**Report: DEFICIENCY REPORT**  
**Function: Test, Adjust, & Balance**  
**Date: 05/01/2025**  
**Completed By: National TAB**

**PROJECT**  
**04-28-25 CULVERS ROCKMART, GA**

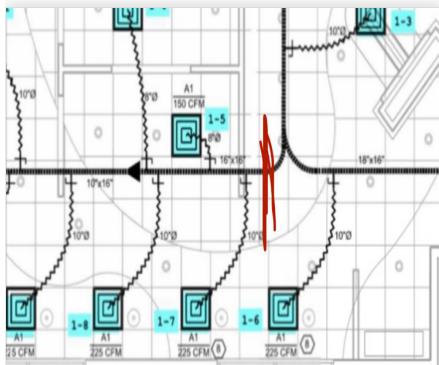
**Issue Name :** AC1 BRANCH DAMPER IS STUCK SHUT  
**Description :** AC1 has a branch damper that is broken and stuck shut. This branch restricts the airflow of diffusers 4, 5, 7, 8, 9, 10, & 11. Until this is fixed, the unit is unable to be balanced.

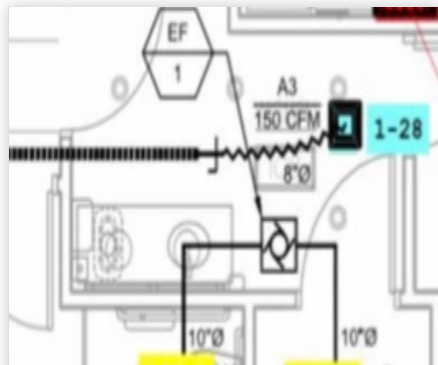
**Issue Name :** AC1 DAMPER HANDLE IS MISSING  
**Description :** The damper for the diffuser in the men's restroom is missing a damper handle.  
**Created By :** National TAB                      **Assigned To :** National TAB - Ben Searles  
**Status :** Closed  
**Priority :** Urgent                                      **Asset Tag :**  
**Originated Date :** 05/01/2025 - Ben Searles - National TAB

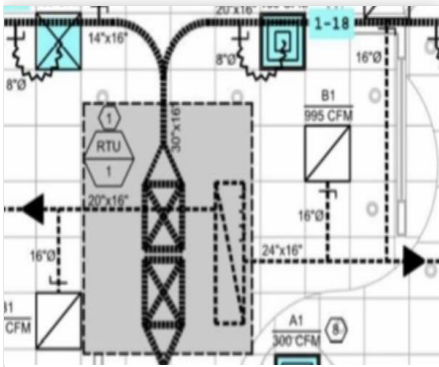
**Issue Name :** AC1 DAMPER INACCESSIBLE  
**Description :** The damper to the diffuser in the women's restroom is located above hard ceiling and is inaccessible. This is where the plans requested it to be located. The damper handle will need to be moved in order to effectively balance the diffuser.  
**Created By :** National TAB      **Assigned To :** National TAB - Ben Searles  
**Status :** Closed  
**Priority :** Urgent      **Asset Tag :**  
**Originated Date :** 05/01/2025 - Ben Searles - National TAB

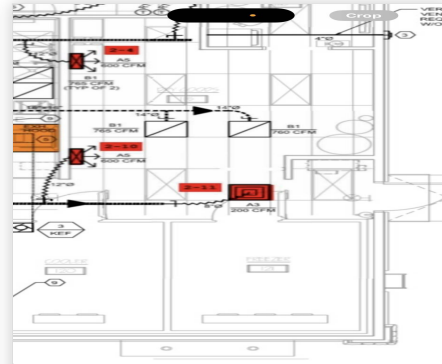
**Issue Name :** AC1 MISSING RETURN AND SUPPLY  
**Description :** AC1 is missing a return as well as supply diffuser 1-18 as depicted in the image below. Without these, the unit is unable to be properly balanced.  
**Created By :** National TAB                      **Assigned To :** National TAB - Ben Searles  
**Status :** Closed  
**Priority :** Urgent                                      **Asset Tag :**  
**Originated Date :** 05/01/2025 - Ben Searles - National TAB

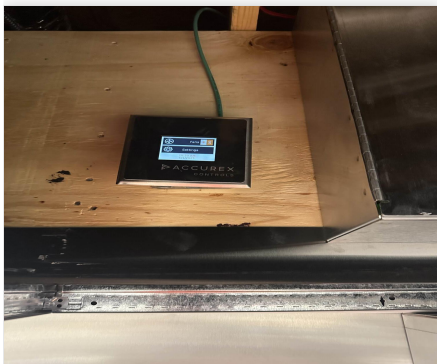
**Issue Name :** AC2 DIFFUSER IS MISSING A DAMPER  
**Description :** Diffuser 11 for AC2 is missing a damper and is unable to be balanced. The mechanical on-site reviewed the ductwork and was unable to locate the damper as well.  
**Created By :** National TAB                      **Assigned To :** National TAB - Ben Searles  
**Status :** Closed  
**Priority :** Urgent                                      **Asset Tag :**  
**Originated Date :** 05/01/2025 - Ben Searles - National TAB
